# Groundwater Transfer Review Summary Form

Transfer/PA # T- 14322

Application: T-14322

Applicant Name: Sunshine Village Water Association

**T-14322**

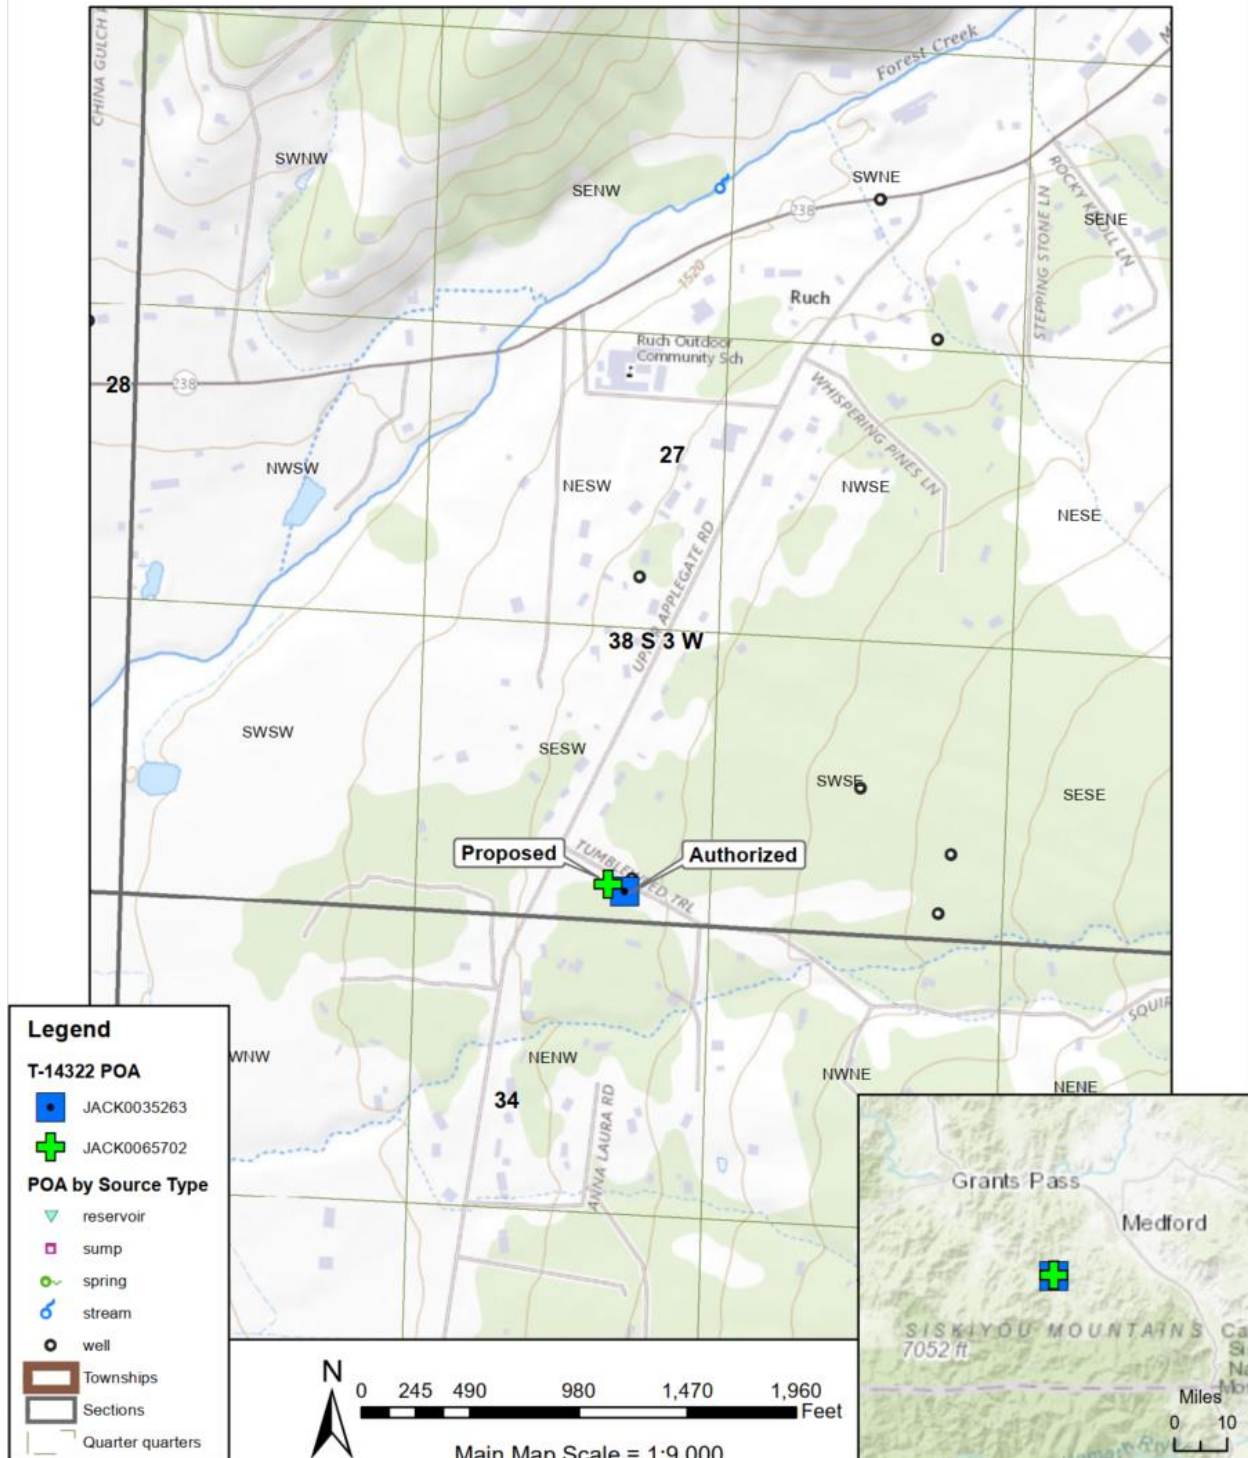
☒ Yes   ☐ No   Comments: The reduced intervening distance between the proposed POA and Forest Creek to the northwest will likely result in an increase in interference when compared to the original, authorized POA.

Provide context for minimal/significant impact: The relatively minor reduction in distance (<100') when compared to the authorized POA would likely result in a minimal change in interference with Forest Creek. Additionally, due to the nature of fractured bedrock aquifers, it is expected that there would be a relatively inefficient connection to surface water that would buffer the timing of impacts to the stream in a manner that would result in a minimal degree of change between the POA locations.
